In the Drawings

Remarks

APPENDIX I: DRAWING PAGES

FIG. 7

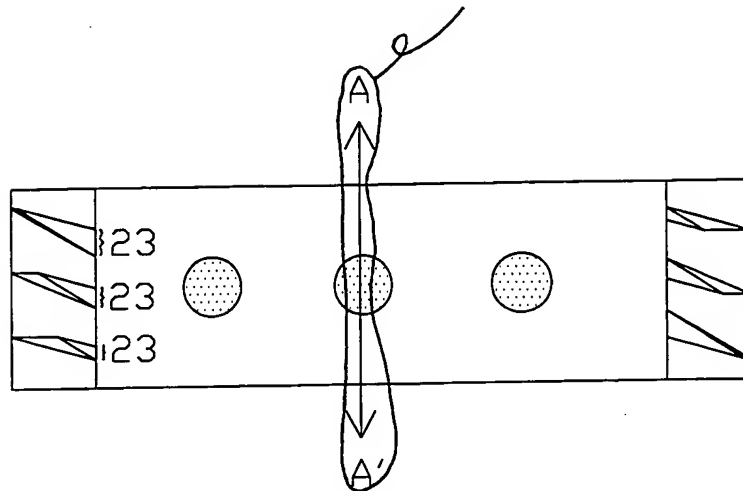
Figure 7 has been amended to delete reference to “longitudinal plane A-A’ ” since it is no longer referred to in the specification, or the claims pursuant to the Examiner’s request and the amendments herein.

FIG. 8

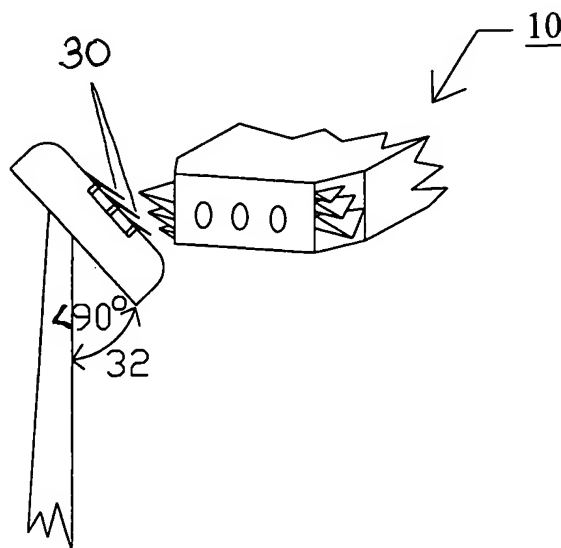
Figure 8 has been amended to include reference numeral **30**, as requested by the Examiner and described in the specification. In addition, the symbol “<” has been inserted before “90°” to clarify that the angle shown is less than 90°.

The drawings have been objected to for failing to comply with 37 CFR §1.84 because reference number "30", as described in the application was not indicated in the figures. As described above, a new drawing page 4 has been attached herewith, along with an annotated sheet showing edits. The new drawing page includes reference number "30". In addition, to coincide with the amendments that will be discussed below, reference to longitudinal plane "A-A" has also been removed from Figure 7. And, as a matter of clarification, a "<" symbol has been inserted in Figure 7 to clarify that the indicated angle is obviously less than 90°. Support for this amendment can be found at page 8, line 16. Applicant respectfully asserts that these amendments do not constitute new matter and respectfully request that the new drawing sheet be included in the application.
